Product Change Notice (PCN)

Subject: Addition of production sites for RL78/G11(24pin), G1F, G13, G14, G1C.

**Difference of specification
(RL78 family HWQFN products)
4mm×4mm 0.5mm pitch 24pin
5mm×5mm 0.5mm pitch 32pin**

MCP-AB-22-0105

4mm×4mm 0.5mm pitch 24pin HWQFN Package outline (Greatek)

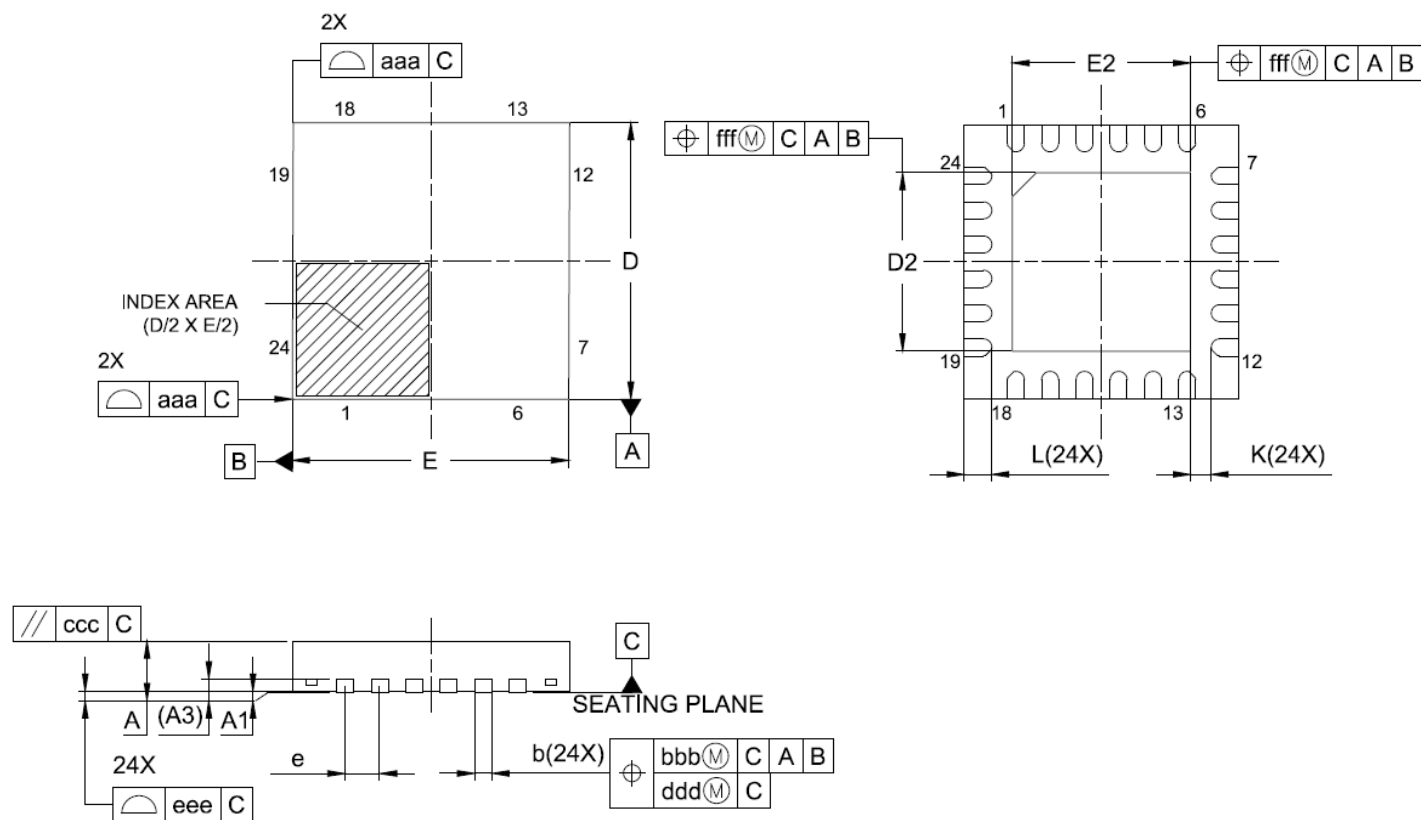
Dimension comparison: 4mm×4mm 0.5mm pitch 24pin HWQFN

UTAC Symbol	4x4mm 24pin HWQFN PWQN0024KH-A			Greatek Symbol	4x4mm 24pin HWQFN PWQN0024KF-A		
	Dimension in Millimeters				Dimension in Millimeters		
	Min	Nom	Max		Min	Nom	Max
A	-	-	0.80	A	-	-	0.80
A1	0.00	-	0.05	A1	0.00	0.02	0.05
A3	0.20 REF.			A3	0.203 REF.		
b	0.20	0.25	0.30	b	0.18	0.25	0.30
D	-	4.00	-	D	4.00 BSC		
E	-	4.00	-	E	4.00 BSC		
e	-	0.50	-	e	0.50 BSC		
N	24			-	-	-	-
L	0.30	0.40	0.50	L	0.35	0.40	0.45
K	0.20	-	-	K	0.20	-	-
D2	2.50	2.60	2.70	D2	2.55	2.60	2.65
E2	2.50	2.60	2.70	E2	2.55	2.60	2.65
aaa	-	-	0.15	aaa	0.15		
bbb	-	-	0.10	bbb	0.10		
ccc	-	-	0.10	ccc	0.10		
ddd	-	-	0.05	ddd	0.05		
eee	-	-	0.08	eee	0.08		
-	-	-	-	fff	0.10

Dimension comparison: 5mm×5mm 0.5mm pitch 32pin HWQFN

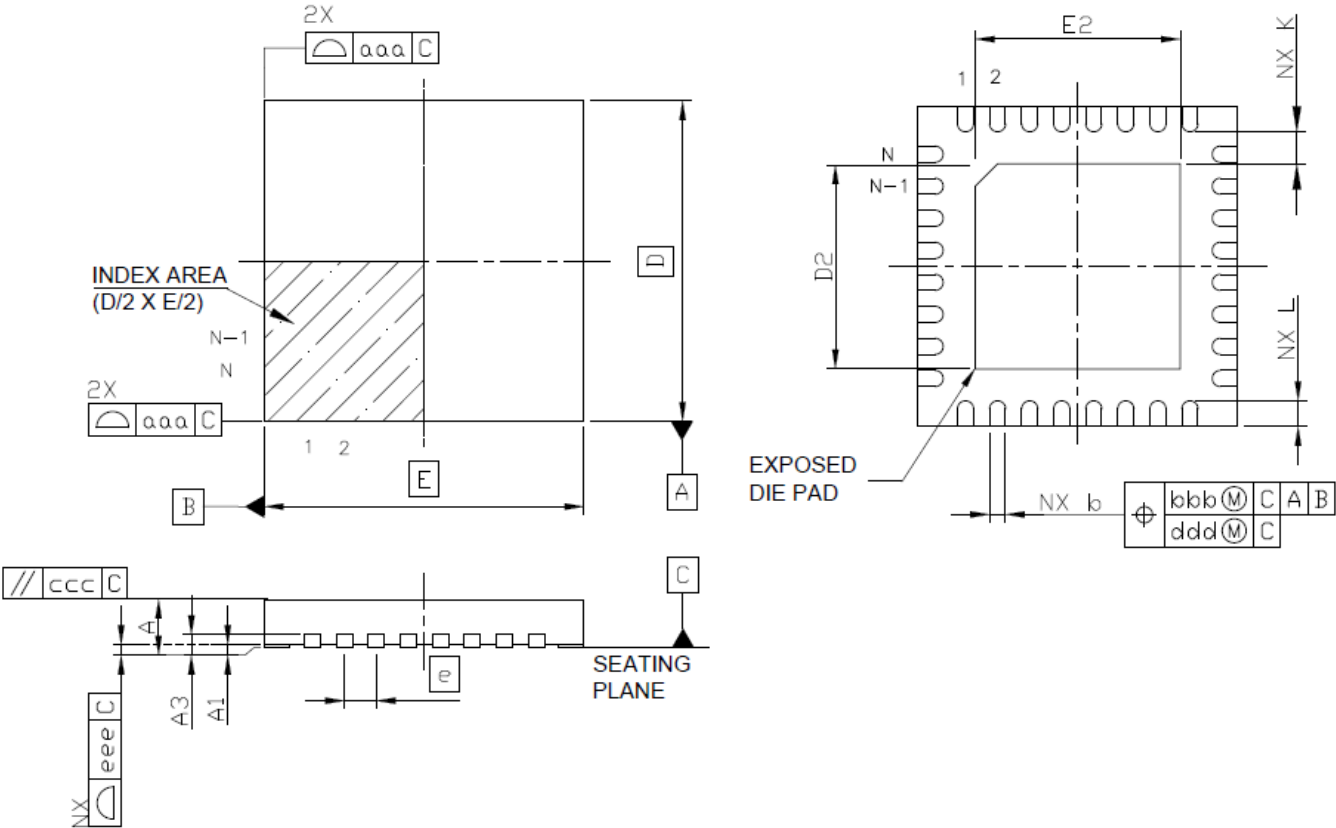
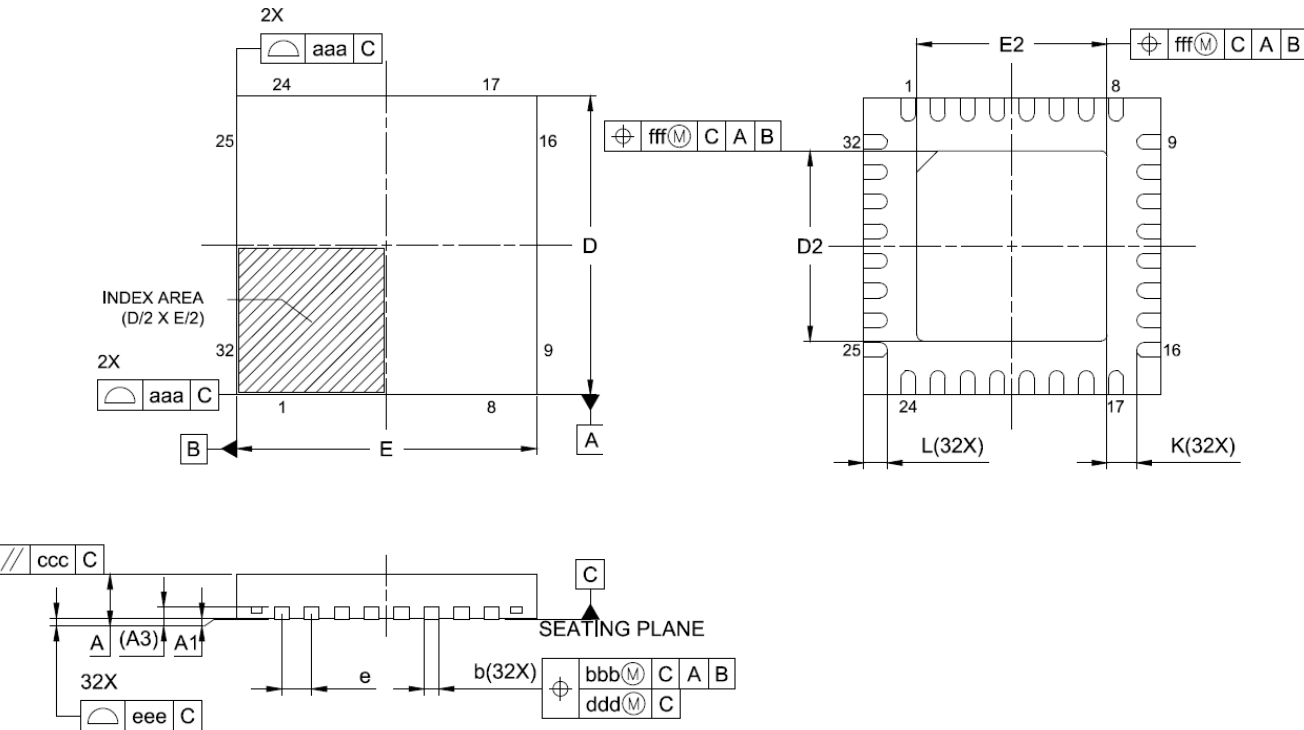
UTAC Symbol	5x5mm 32pin HWQFN PWQN0032KG-A			Greatek Symbol	5x5mm 32pin HWQFN PWQN0032KE-A		
	Dimension in Millimeters				Dimension in Millimeters		
	Min	Nom	Max		Min	Nom	Max
A	-	-	0.80	A	-	-	0.80
A1	0.00	-	0.05	A1	0.00	0.02	0.05
A3	0.20 REF.			A3	0.203 REF.		
B	0.20	0.25	0.30	b	0.18	0.25	0.30
D	-	5.00	-	D	5.00 BSC		
E	-	5.00	-	E	5.00 BSC		
e	-	0.50	-	e	0.50 BSC		
N	32			N	-	-	-
L	0.30	0.40	0.50	L	0.35	0.40	0.45
K	0.20	-	-	K	0.20	-	-
D2	3.10	3.20	3.30	D2	3.15	3.20	3.25
E2	3.10	3.20	3.30	E2	3.15	3.20	3.25
aaa	-	-	0.15	aaa	0.15		
bbb	-	-	0.10	bbb	0.10		
ccc	-	-	0.10	ccc	0.10		
ddd	-	-	0.05	ddd	0.05		
eee	-	-	0.08	eee	0.08		
-	-	-	-	fff	0.10

Package structure image

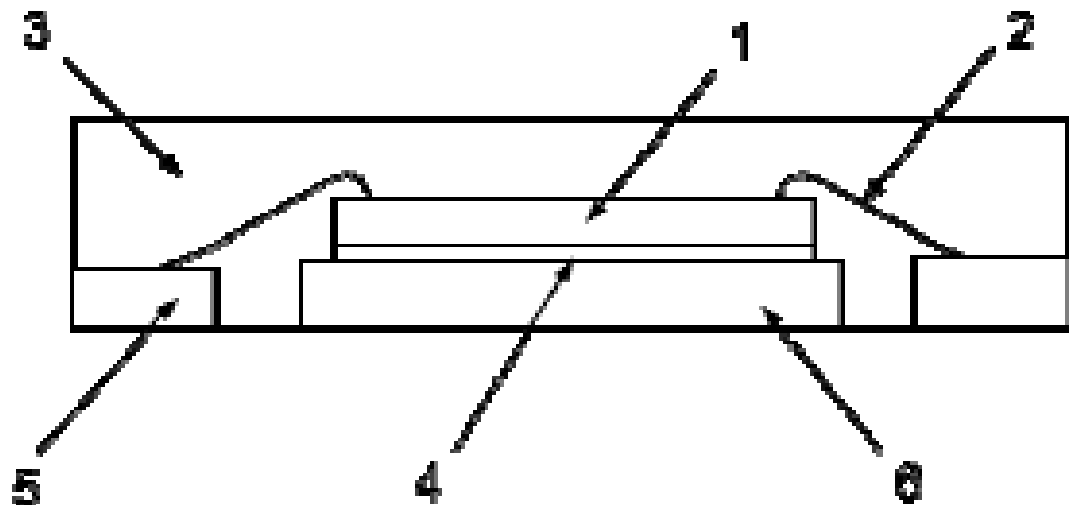
* Different materials will be used at UTAC but their structure is same as those conventionally used.

Marking visibility

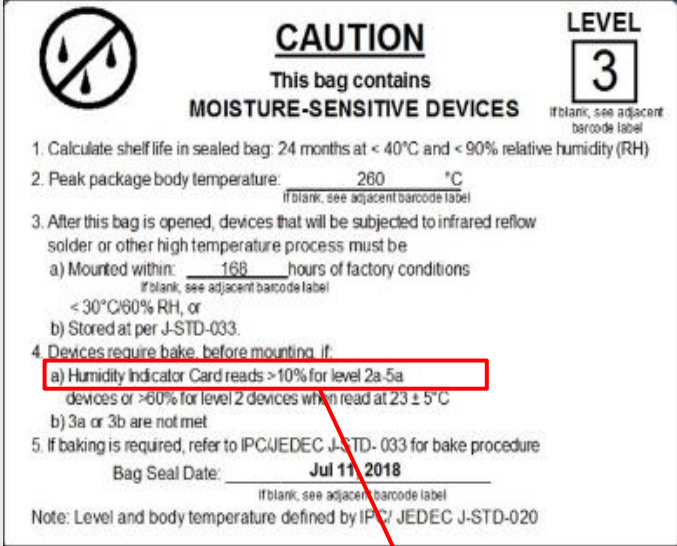
Change the marking font.

Assembly site	Additional (UTAC)	Existing (Greatek)
Overall photo		
Enlarged photo

Packing specification for Tray

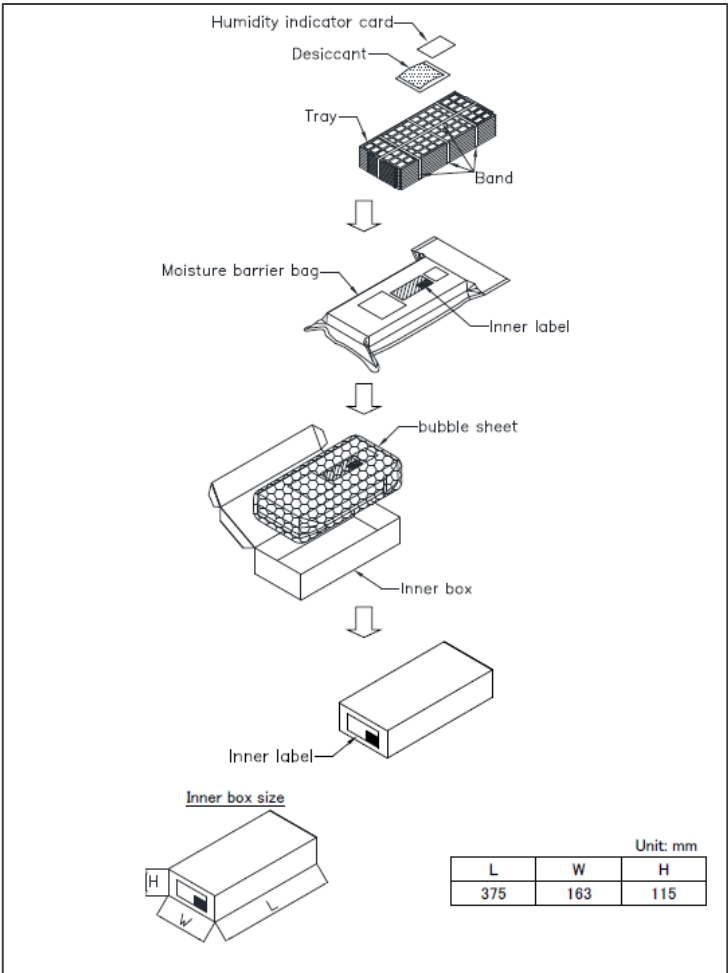
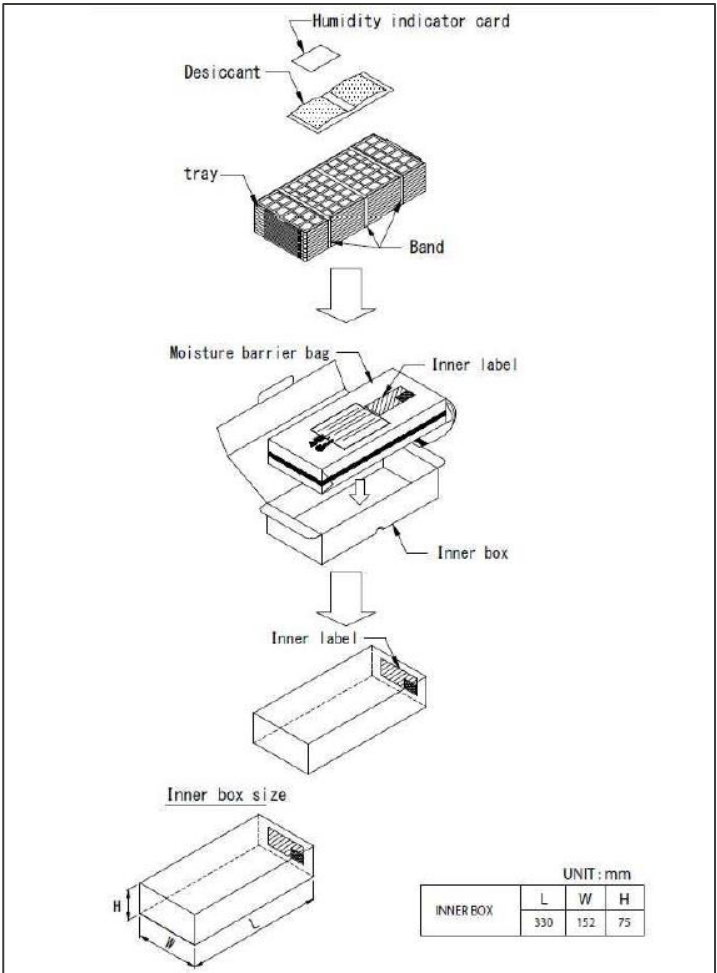
Packing material	Tray	
	Additional (UTAC)	Existing (KYEC)
Moisture barrier bag *Refer to page 18 for printed characters.	•Size : 228.6mm×508mm Inner label Caution label 	•Size : 250mm×510mm Inner label 
Inner box	•Size : 163mm×375mm×115mm  Bubble sheet  Inner Box Filament tape Inner label	•Size : 152mm×330mm×75mm   Inner Box  Inner label

Dimension comparison: 4mm×4mm 24pin HWQFN Emboss tape

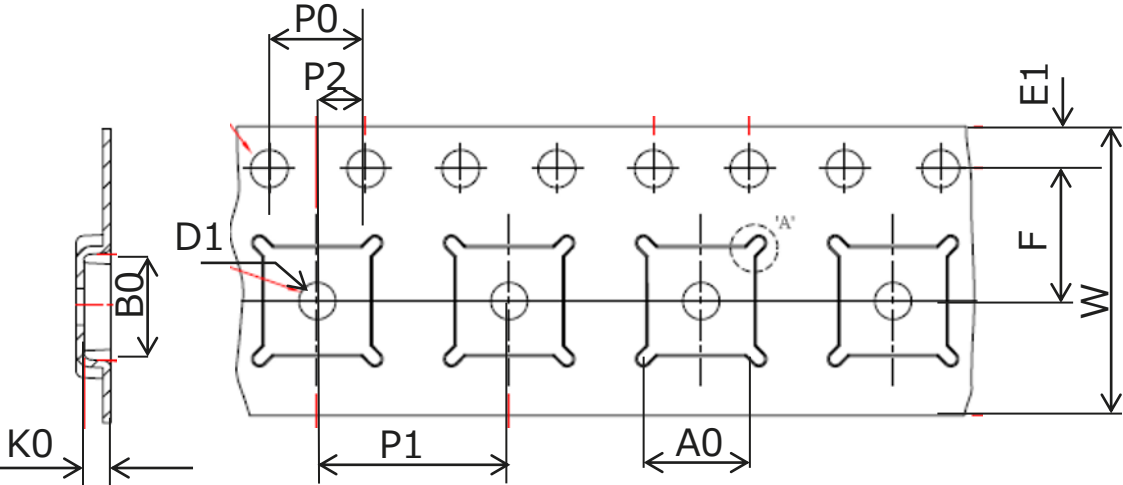
Symbol	Additional (UTAC)	Existing (KYECC)
A0	4.30	4.25
B0	4.30	4.25
K0	1.10	1.10
P1	8.00	8.00
W	12.00	12.00
E1	1.75	1.75
P0	4.00	4.00
F	5.50	5.50
P2	2.00	2.00
D1	Φ1.50MIN	Φ1.60

Dimension comparison: 5mm×5mm 32pin HWQFN Emboss tape

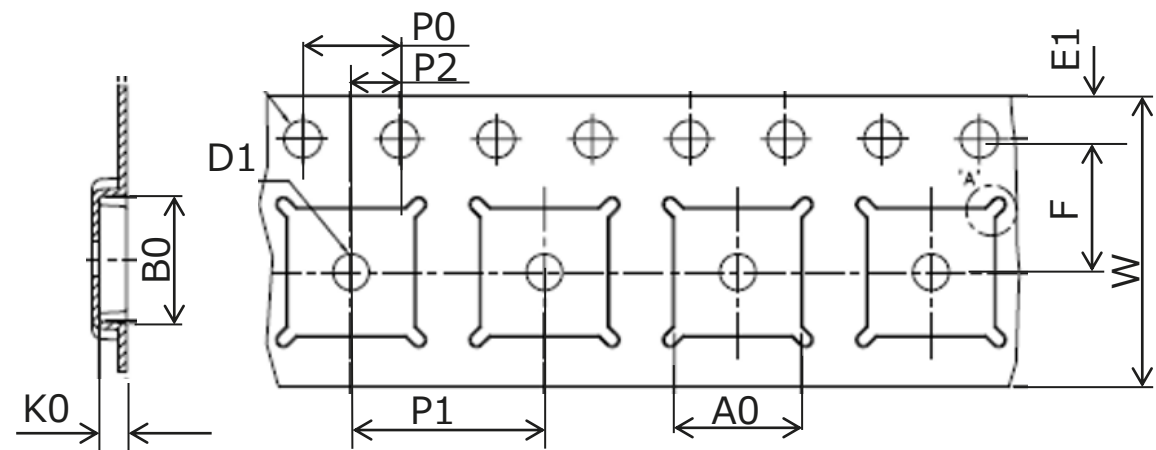
Symbol	Additional (UTAC)	Existing (KYEK)
A0	5.25	5.30
B0	5.25	5.30
K0	1.10	1.10
P1	8.00	8.00
W	12.00	12.00
E1	1.75	1.75
P0	4.00	4.00
F	5.50	5.50
P2	2.00	2.00
D1	Φ1.50MIN	Φ1.60

Dimension comparison: Reel (HWQFN common)

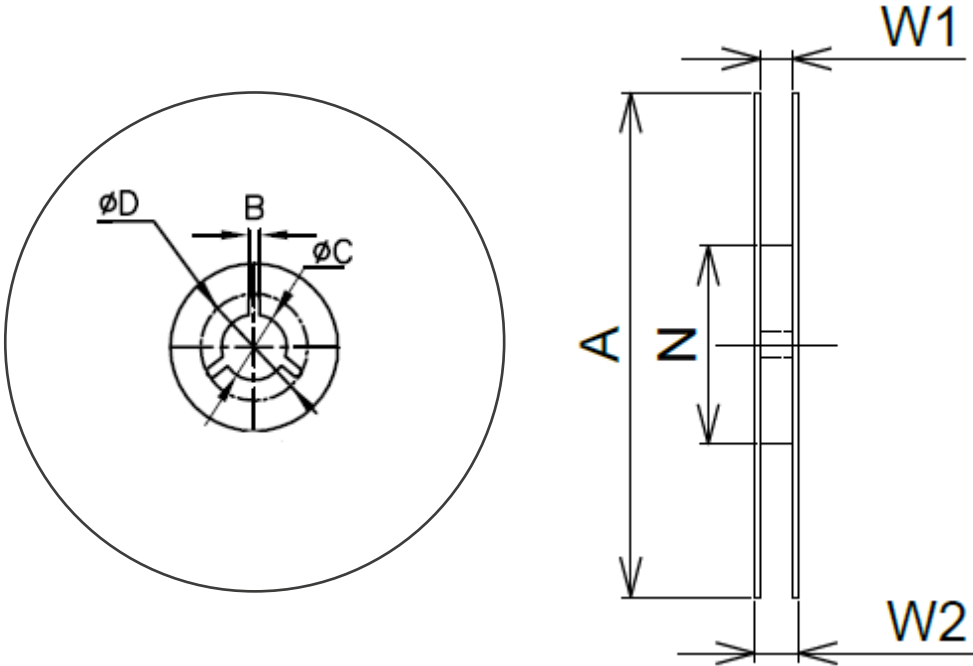
Symbol	Additional (UTAC)	Existing (KYEK)
B	1.5	2.0
ϕC	13.0	13.0
ϕD	20.2	21.0
A	330	330
N	100	102
W1	12.4	12.8
W2	18.4	18.4

Packing specification for Tape & Reel

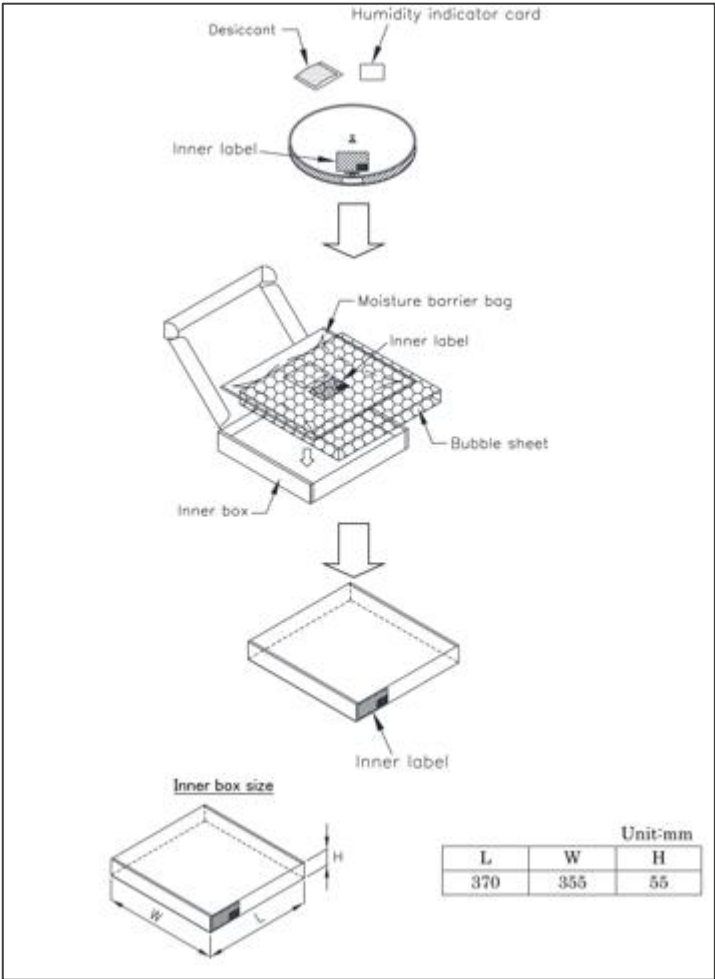
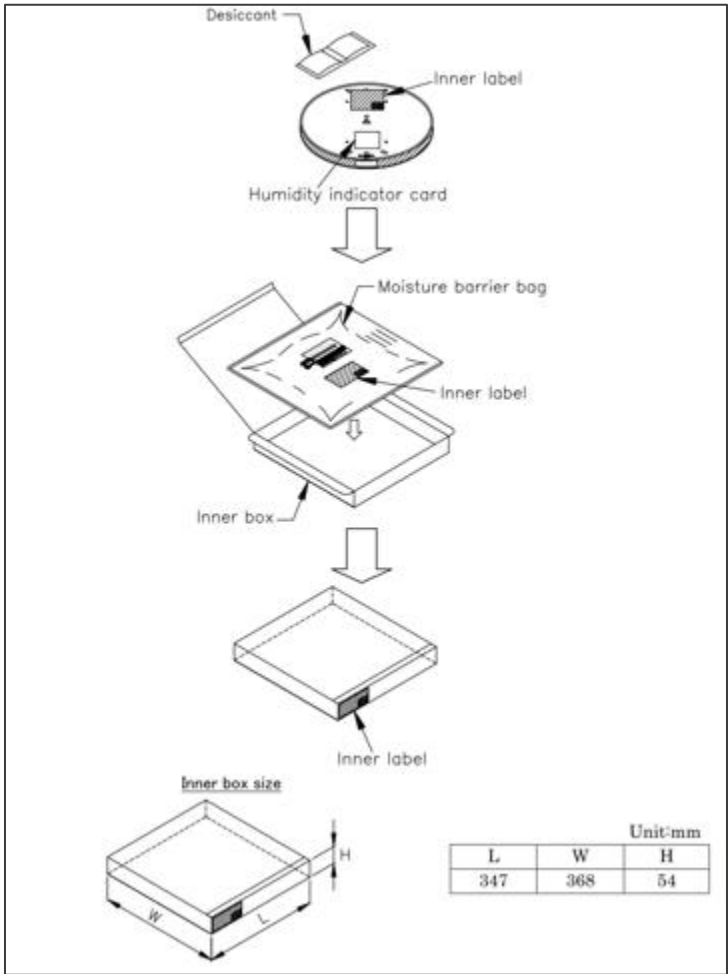
Packing material	Tape & Reel	
	Additional (UTAC)	Existing (KYEC)
Moisture barrier bag *Refer to page 18 for printed characters.	•Size : 406.4mm×457.2mm  Inner label Caution label  Bubble sheet	•Size : 415mm×500mm  Inner label
Inner box	•Size : 370mm×355mm×55mm  Inner Box Inner label	•Size : 347mm×368mm×54mm  Inner Box Inner label
Desiccant	•Weight : 33g 	•Weight : 25g+25g
